Re: 1010 Pipe and Casing
5609 Alameda Pl. NE
Traffic Circulation Layout
Architect's Stamp 03-XX-23 (C18-D015)

Based upon the information provided in your submittal received 07-11-23, the above referenced plan cannot be approved for Building Permit until the following comments are addressed:

1 Site Plan

1010 Pipe and Casing

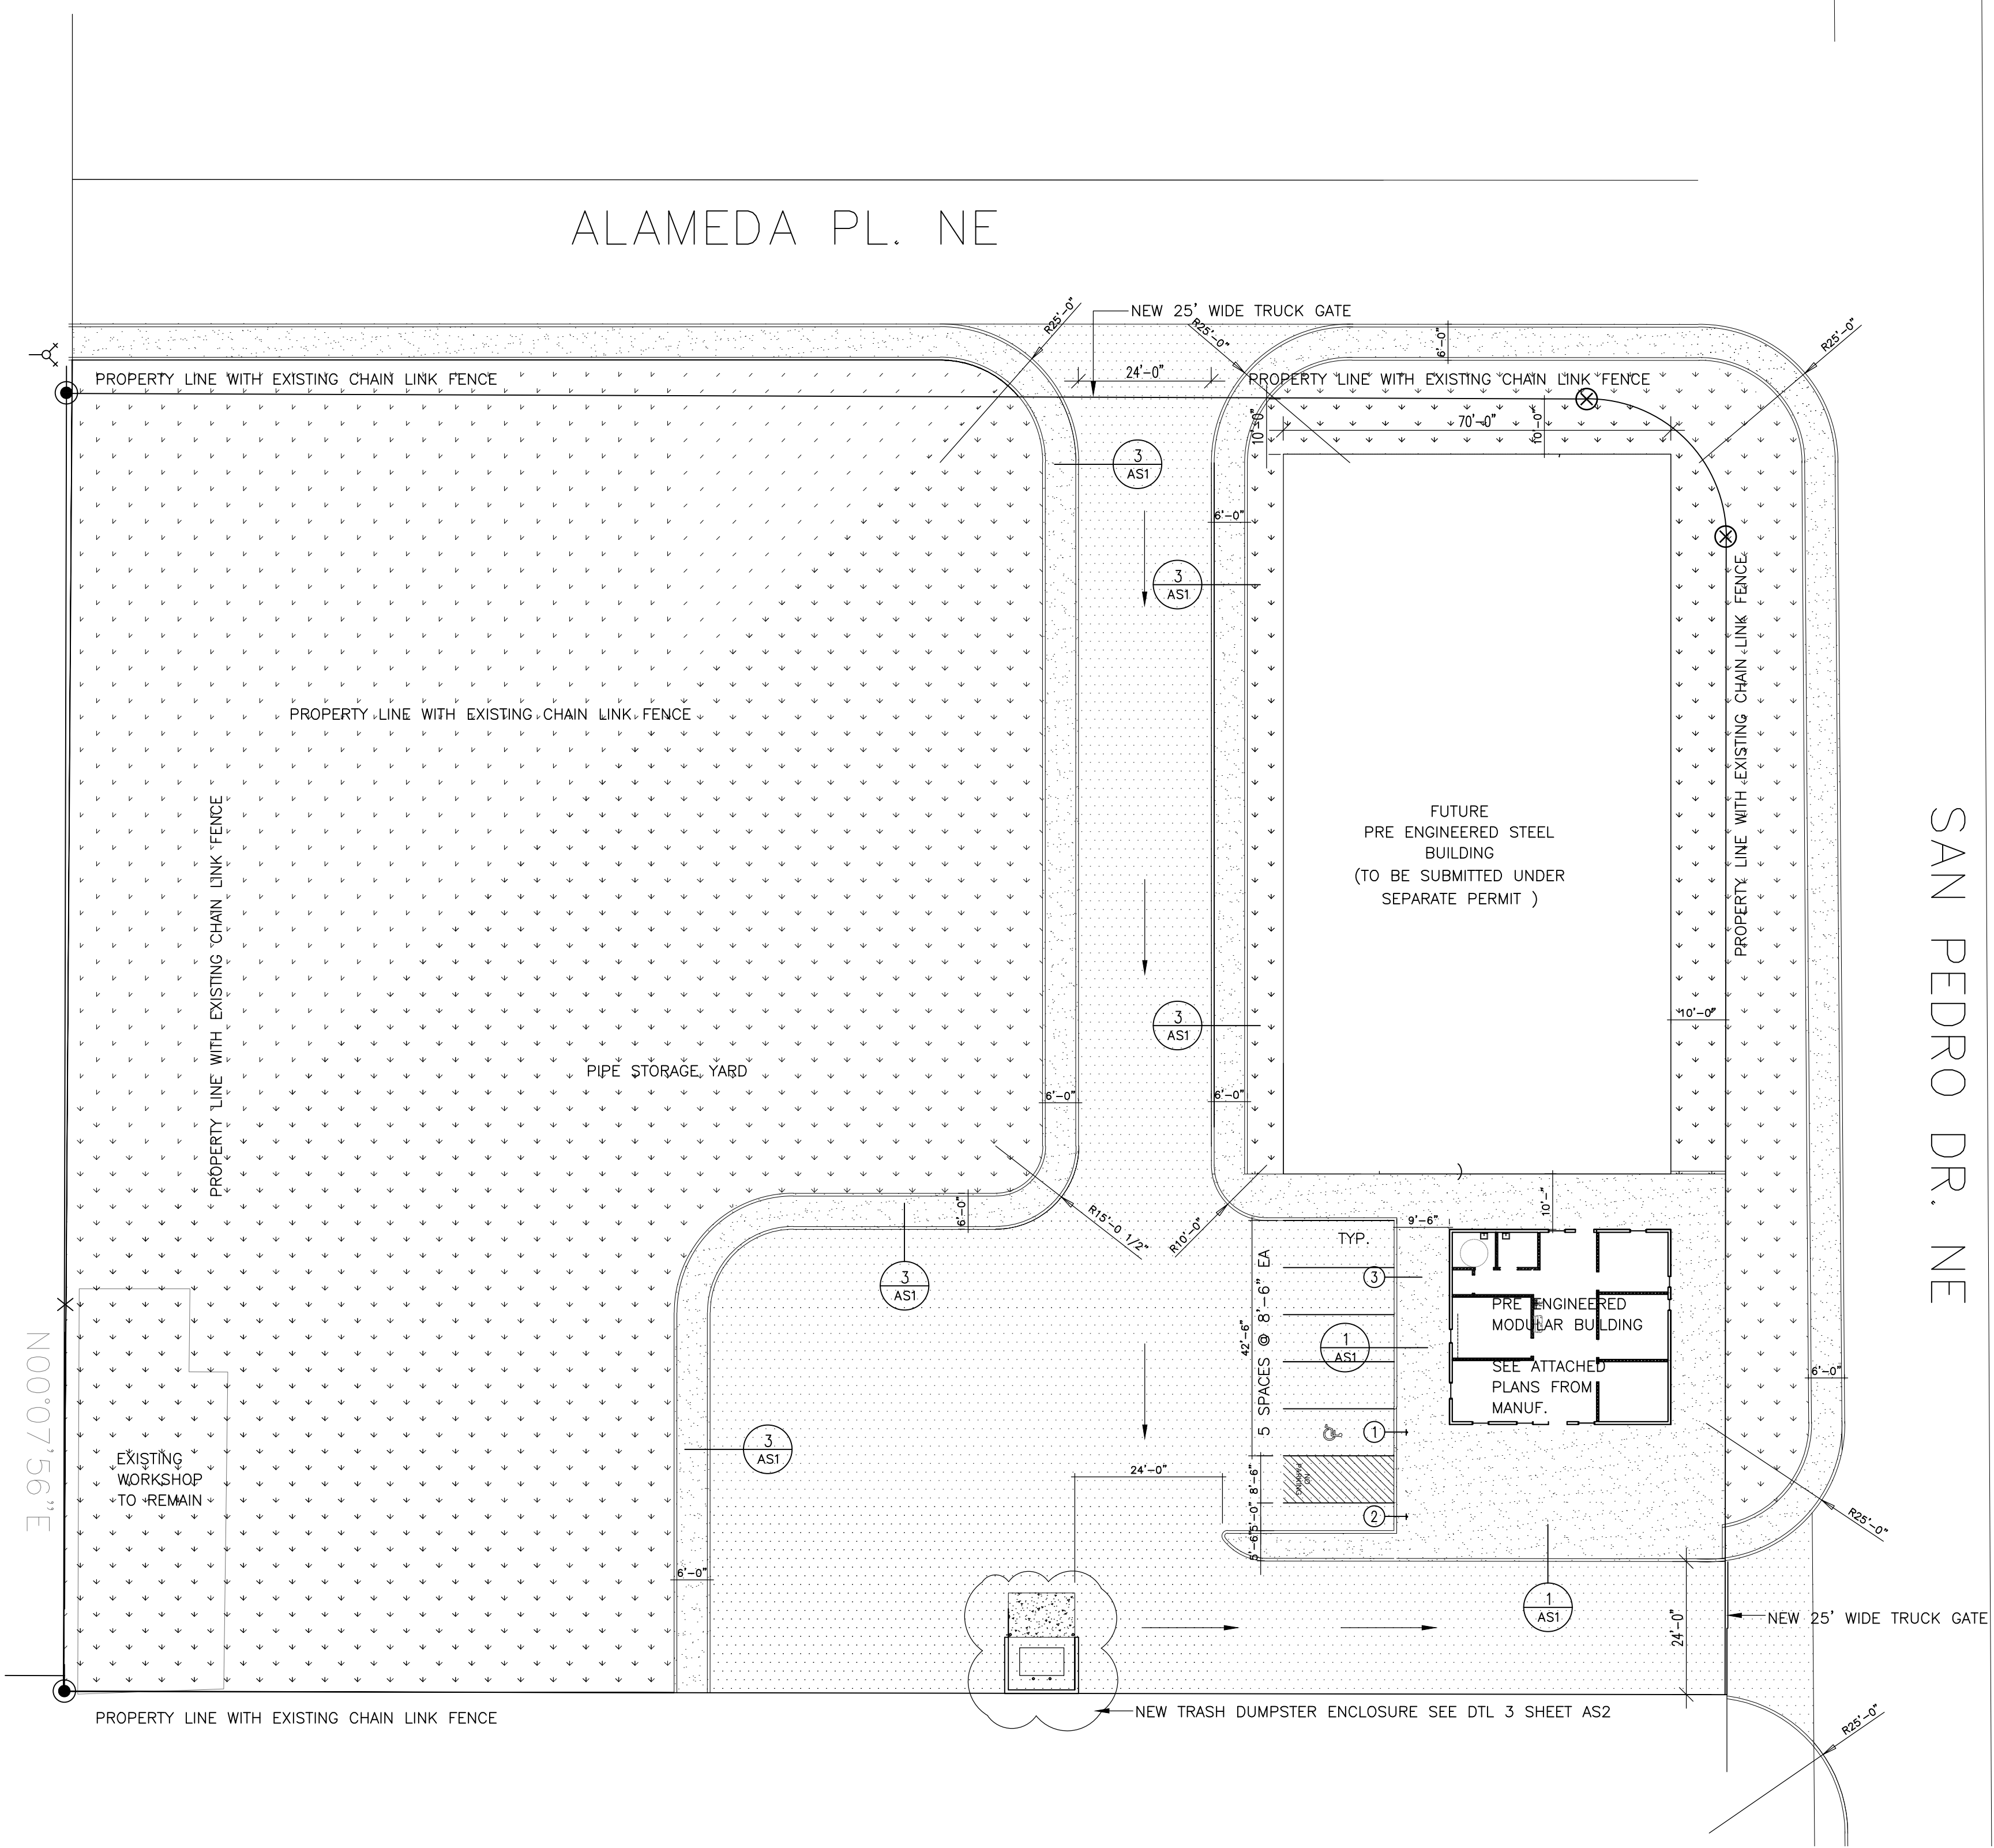
1. List the number of Bicycle parking spaces required by the IDO.
2. The traffic circulation layout must be dated by an engineer or architect licensed in the state of New Mexico.

3. Identify all existing access easements and rights of way width dimensions.
4. Identify the right of way width, medians, curb cuts, and street widths on Alameda Pl. and San Pedro Dr.

5. Please provide design details for both proposed driveways and reference COA std dwg.
6. ADA curb ramp at the corner of Alameda Pl. and San Pedro Dr. must be built to current standards and have truncated domes installed. Please provide design details and reference COA std dwg.

7. Please reference COA std dwg 2430 for the proposed sidewalk.
8. Please show on the site plan a minimum 20 ft. setback for the proposed gates.
9. It appears that the proposed driveway off San Pedro will encroach with the south side adjacent property. Please provide adjacent property owner agreement.

10. Details sheet is missing.
11. The ADA accessible parking sign must have the required language per 66-7-352.4C NMSA 1978 **"Violators Are Subject to a Fine and/or Towing."** Please call out detail and location of signs.

12. The pavement marking "MC" should be shown in the opposite direction for motorcycles entering the parking space.
13. All bicycle racks shall be designed according to the following guidelines:

14. Bicycle racks shall be sturdy and anchored to a concrete pad.
15. A 1-foot clear zone around the bicycle parking stall shall be provided.
16. Bicycle parking spaces shall be at least 6 feet long and 2 feet wide.

17. Per DPM, a 6 ft. wide ADA accessible pedestrian pathway is required from the ADA parking stall access aisles to the building entrances. Please clearly show this pathway and provide details.

18. ADA accessible pedestrian pathway should not be placed behind parking space or adjacent to a vehicular way. Vehicle and pedestrian/wheel chair conflicts should be avoided as much as possible.

19. Curbing should be installed to delineate landscape, parking, and pedestrian ways and identify points of access. Please call out detail and location of barrier curb.

20. Refuse vehicle maneuvering shall be contained on-site. The refuse vehicle shall not back into the public right of way.; provide a copy of refuse approval.

21. Provide a copy of Fire Marshal approval.
22. Show the clear sight triangle and add the following note to the plan: "Landscaping and signage will not interfere with clear sight requirements. Therefore, signs, walls, trees, and shrubbery between 3 and 8 feet tall (as measured from the gutter pan) will not be acceptable in the clear sight triangle.
